Lift strut attachment mod kit

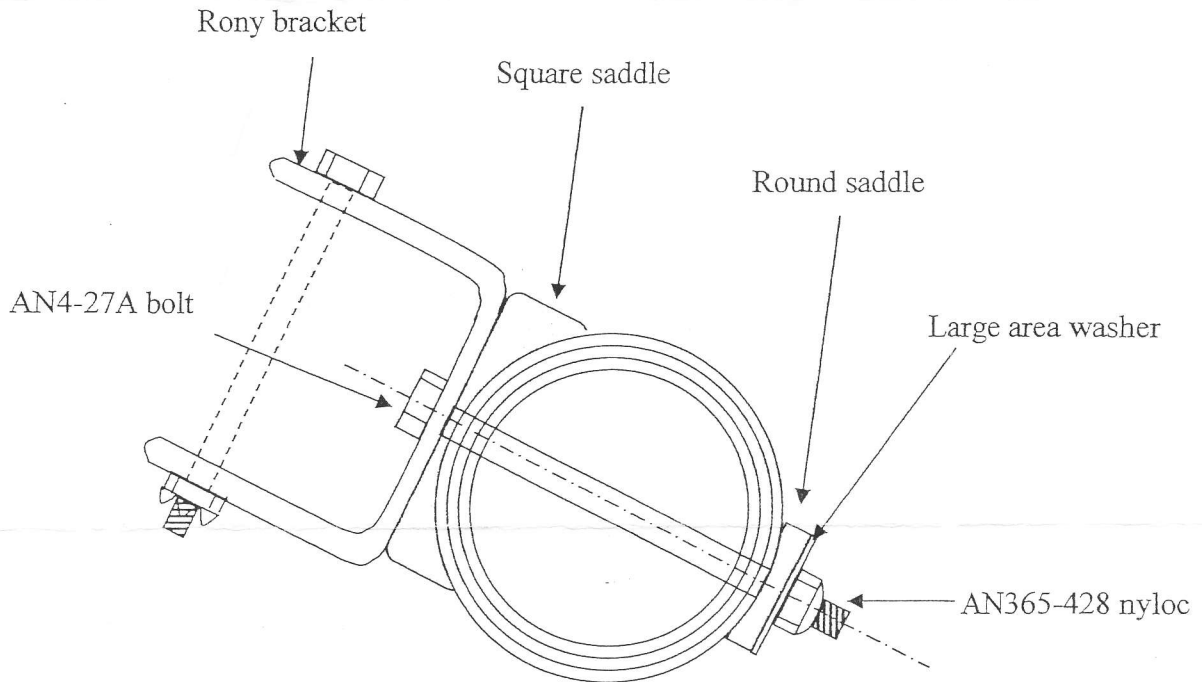
Note: There is no torque value with the AN4-27A bolt and nyloc nut. Just snug it down until you feel some pressure. **DO NOT OVERTIGHTEN** as this could compress or distort the longeron. Some slackness may be desired to allow the rony bracket to twist. This will make the installation of the lift struts a little easier. Once lift struts are secured, snug down the nyloc nut.

IMPORTANT. You **MUST** fit all saddles to all 4 lift strut Rony brackets. If not, you may experience some adverse flight characteristics due to un-even wings.

- 4-- 4330-2 square alum. Saddle
- 4-- 4329 round alum. Saddle
- 4-- AN4-27A bolt, 1/4"
- 4-- AN365-428 nyloc nut
- 4-- AN970-4 washer, lg. Area AN 1/4"
